EXTERNAL CORRESPONDENCE

The City Clerk's Office received the
attached correspondence regarding the
Jean Sweeney Park Master Plan

Lara Weisiger - Jean Sweeney Open Space Park

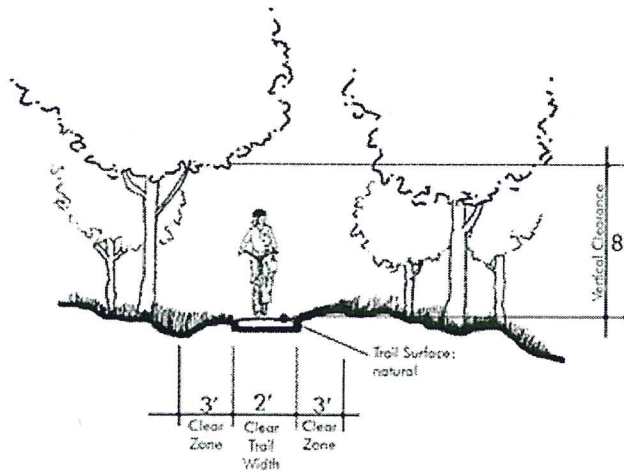
I now see in the current plan going before the City Council that the bike skills loop crosses the walking path in at least 9 places. I see that as a huge problem. As a person who walks every weekend along the Alameda Shoreline walk/bike path I am constantly protecting myself from being run off the path by aggressive bikers. And these are just normal bikers not biking skills riders. You must be aware that there are conflicts between these two pursuits and there has already been much talk about redesigning the Alameda Shoreline path so that the walkers and bicyclers don't share the same path. There will, be accidents and injuries for certain if these two paths are crossed in so many places. And it certainly wouldn't be a place where elderly or disabled people would be comfortable. Why would we want to create a new park with these same problems. I am not against bicyclists at all. I love to cycle myself. But I have seen over the years that the two pursuits do not mix well. It would be very easy at this point to redesign the bike loop path so that it does not intersect the walking path at all. I request that that be done before moving forward.

Thank you for your feedback. As this is a Master Plan, details such as the exact location of the pedestrian only trails will be determined when the landscape design is done. So the specific location of crossings and type of crossings will be determined at a later date. However, I understand your concerns and also want to share that the bike skills trail will have a number of "elements" for bikes to maneuver around so these will not be bikes zipping along at a fast clip. In addition, we will be conscientiously placing specific elements at any crossing points to slow the bikers down to a near stop. For example, by placing a few boulders right before a crossing, it forces the biker to slow down and move around the boulders prior to the pedestrian crossing. I've attached a sample of the elements that I'm referring to.
